# Site Accessibility Evaluation

### Fire Station 19

**2490 Research Pkwy  
Colorado Springs, CO  
80920**

SUBJECT: Fire Station 19 Self-Evaluation

### Finding: 3

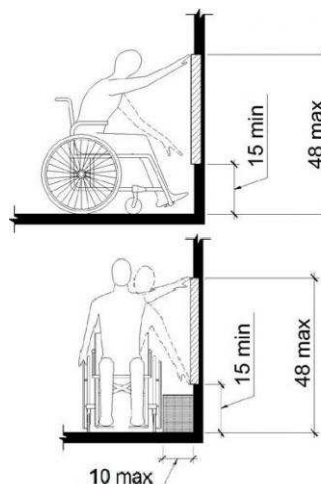
The door bell is positioned too high for either a side or front approach.

The door bell in the foyer is mounted at 49-1/2".

Lower the door bell to at or under 48".

### Finding: 4

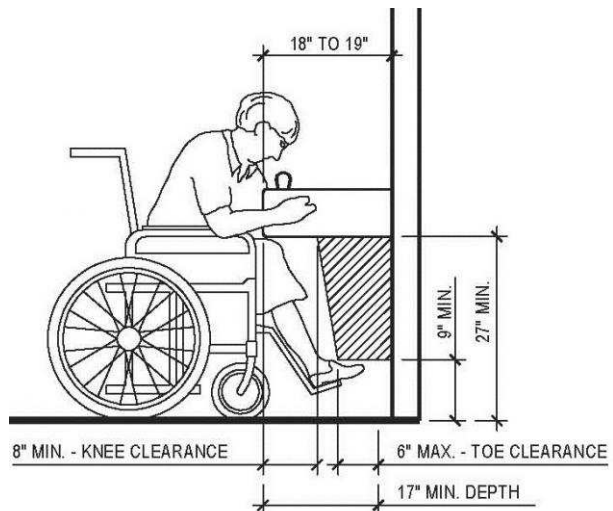
There is not enough knee clearance under the drinking fountain.

The drinking fountain has 26-1/2" knee clearance.

Raise the drinking fountain 1/2".

### **Finding: 5**

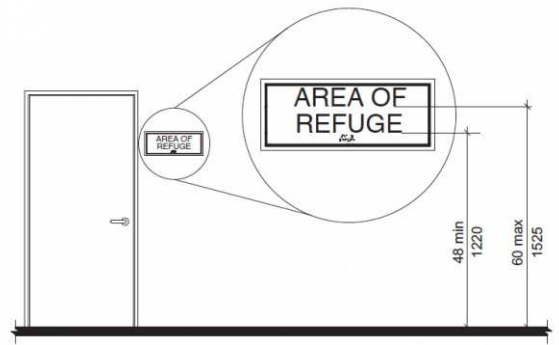
The wall sign is mounted too high.

The signage for the community room is mounted at 84" above the double doors.

Install a tactile/Braille sign to the right side of the double doors 60" to the top edge.

### Finding: 8

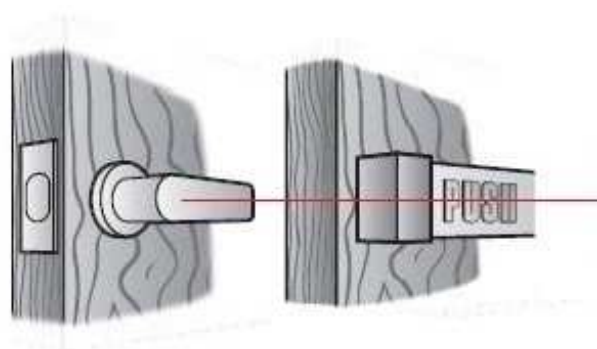
The force required to operate the door hardware exceeds the maximum.

The restroom door requires 20 lbs of force to operate.

Adjust the door closer to 5lbs force to operate.

### Finding: 9

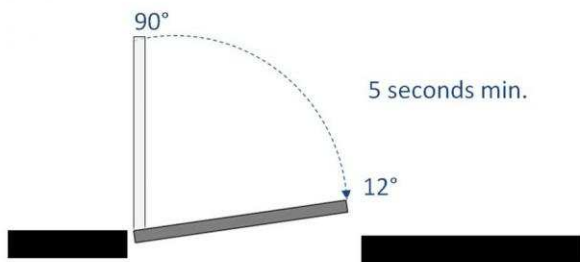
The door is equipped with a door closer and returns to a closed position too quickly.

The restroom door closes too fast.

Adjust the door closer.

### Finding: 11

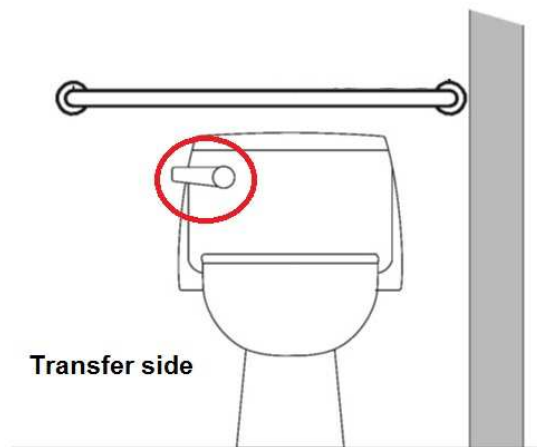
The flush handle is located on the wrong side of the toilet.

The flush handle is on the wrong side of the toilet.

Install a new tank with the flush handle on the open side.

### Finding: 12

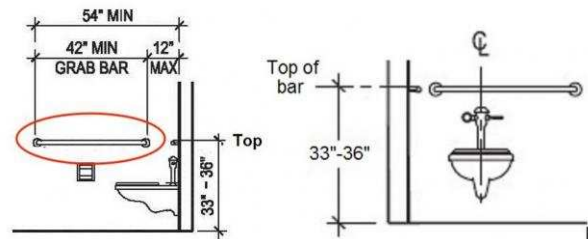
The side and rear grab bars are too high.

The grab bars are mounted at 36-3/4".

Lower the grab bars to under 36" to the top edge.

### Finding: 14

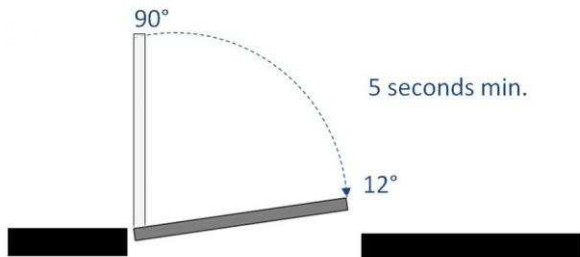
The door is equipped with a door closer and returns to a closed position too quickly.

The door into the restroom closes too fast.

Adjust the door closer.
